NEPAL ELECTRICITY AUTHORITY

Distribution System Control and Data Centre Project
Khanepur, Bhaktapur

Subject:- Issuance of Clarification – 2

Ref:- Design, Supply, Installation and Commissioning of Distribution Command and Control Centre (OCB:- PMD/EGMP/DCC -077/78 -01)

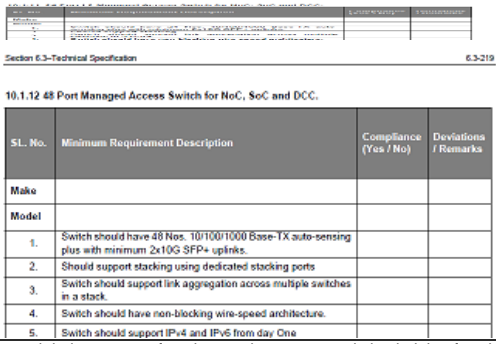
| 125 | RTU shall be compatible with protocol 61850 for communication with IEDs | Kindly confirm the no. of IEDs over IEC 61850 each substation which will be communicating with RTUs. | As per RFP and Subsequent Amendment |
